WATER LICENCE INSPECTION FORM

Licensee	Licensee Representative
BAFFINLAND IRON MINES CORPORATION	William Bowden
Licence No. / Expiry	Representative's Title
2AM-MRY1325	Environmental Superintendent
Land / Other Authorizations	Land / Other Authorizations
8BC-MRY1416, 2BE-MRY1421	N2014X0012, N2014Q0016, N2014C0013
Date of Inspection	Inspector
August 22-23, 2018	Jonathan Mesher
Activities Inspected	
<input type="checkbox"/> Camp	<input type="checkbox"/> Drilling
<input type="checkbox"/> Roads/Hauling	<input checked="" type="checkbox"/> Mining
	<input type="checkbox"/> Construction
	<input type="checkbox"/> Reclamation
	<input type="checkbox"/> Fuel Storage
	<input type="checkbox"/> Other:

Photo 3

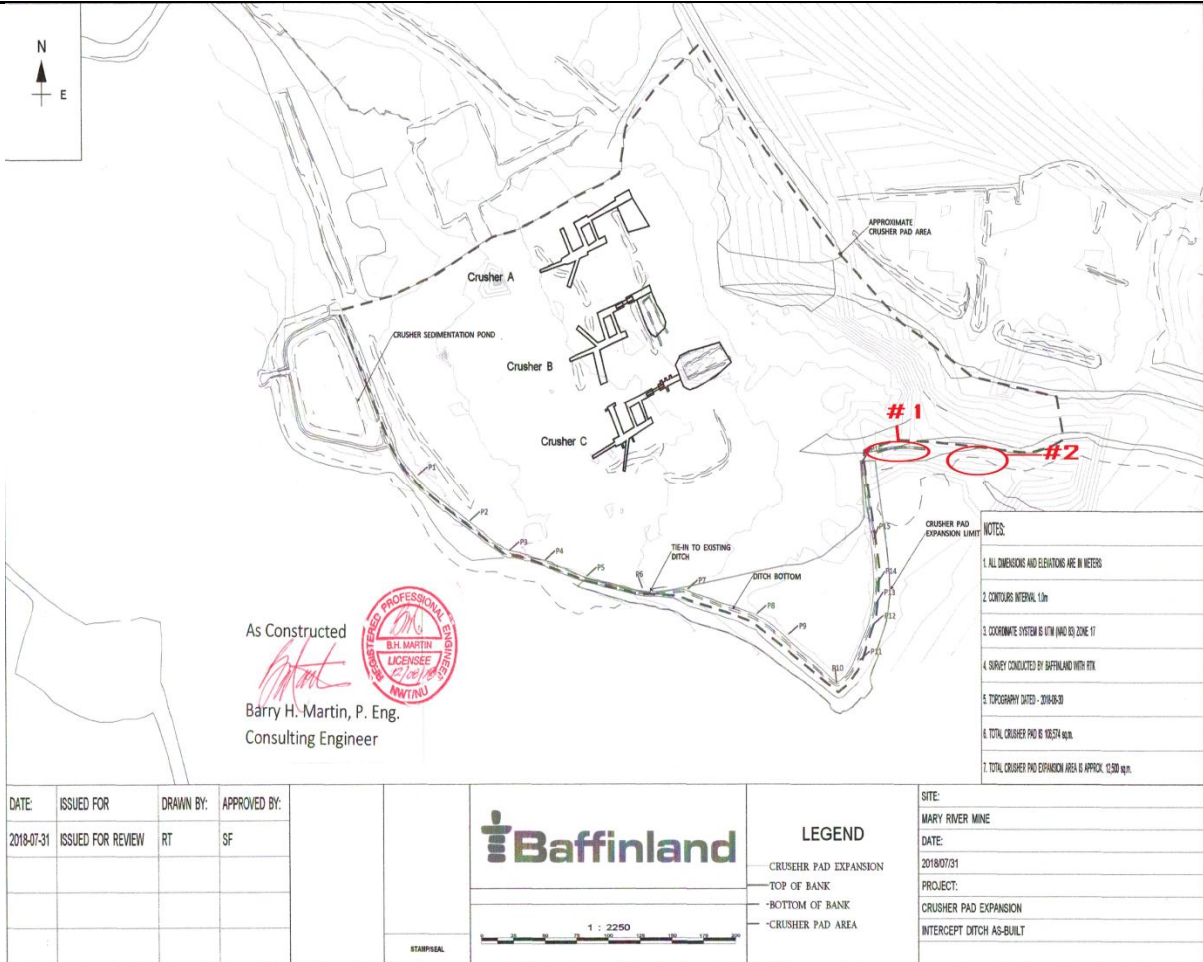
c. During the inspection it was noted that, a pile of iron ore is outside of containment. Please remove the ore from outside containment, see Photo 3. A red circle labeled "#2" identifies the misplaced iron ore's location.

- I. "All drainage ditches should be of trapezoidal cross sections, where possible." This does not appear to be applied at the location identified in photo #3. A red circle labeled "#1" identifies this location.

Photo Log #
Photo 12

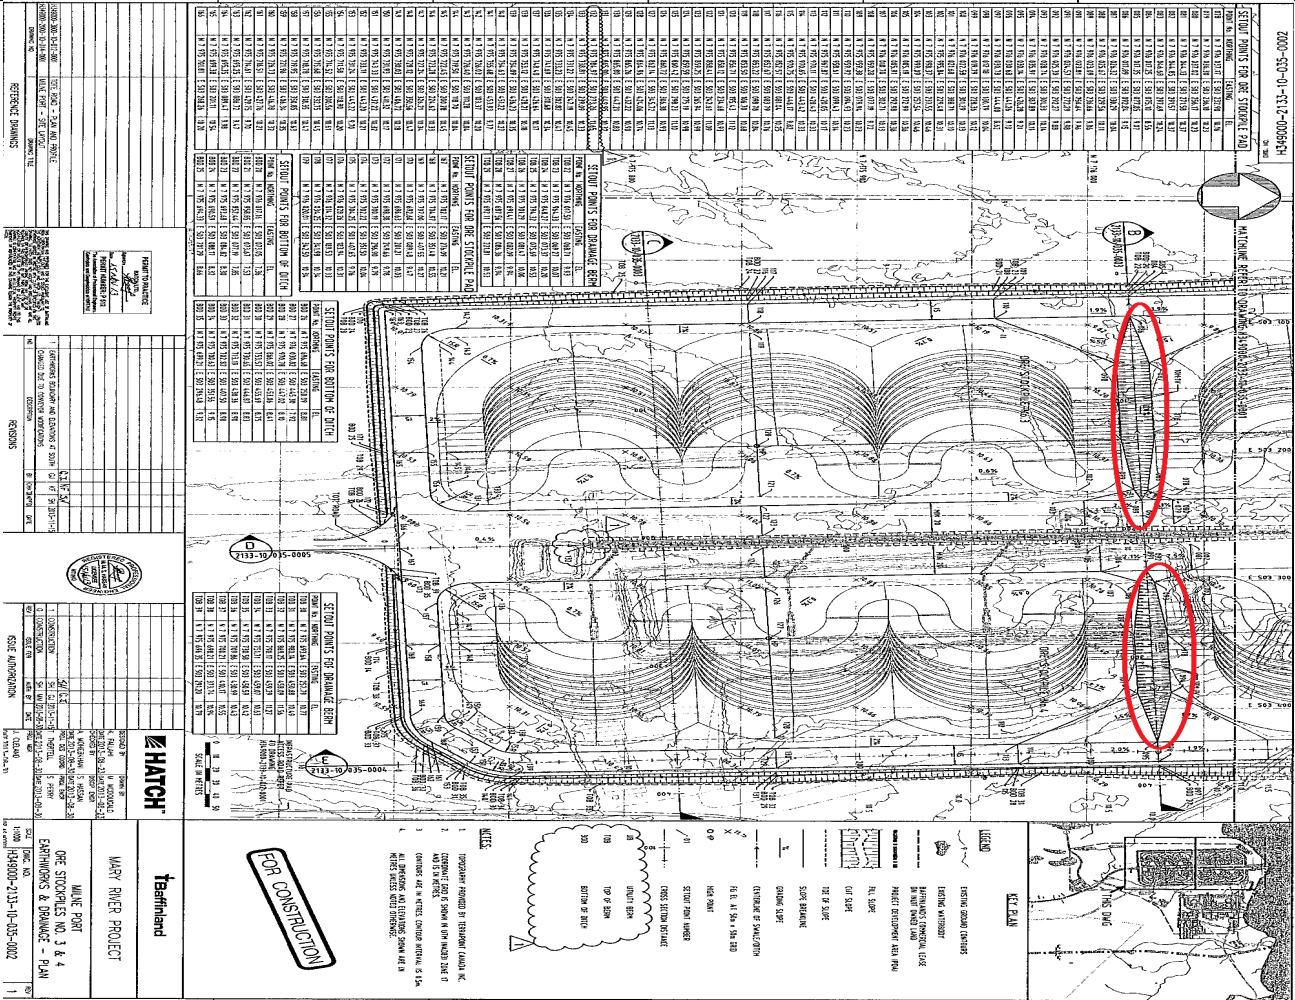
- a. During the inspection it was noted that the swales highlighted in photo #12 have not been installed/implemented.
- b. There was ore outside containment on the South-West corner of the facility; the licensee is to recover this Ore from outside containment.
- c. The ditch on the East side of the conveyer belt appears to be sloping away from the sedimentation pond.
- d. Remnants of the original bulk sample are still left outside of containment to the east of the west sedimentation pond; Baffinland is to remove the remainder of the bulk sample.

Description; Swales circled in red do not appear implemented.

4. Once the Ore stockpile pad is clear of Ore, the licensee is to clear the swales highlighted in photo #12 and keep them clear of Iron Ore so that the pad operates as intended.
5. The licensee is to ensure that the slope of the ditches surrounding the Ore Stockpile Pad corresponds with the approved design.
6. The licensee is to return the Western Global Fuel module at Milne Inlet to its original approved design.
7. The licensee is to correspond with the NWB and follow the required processes to install the required water management structures to prevent water from flooding the roads identified in Photo's 14 and 15.
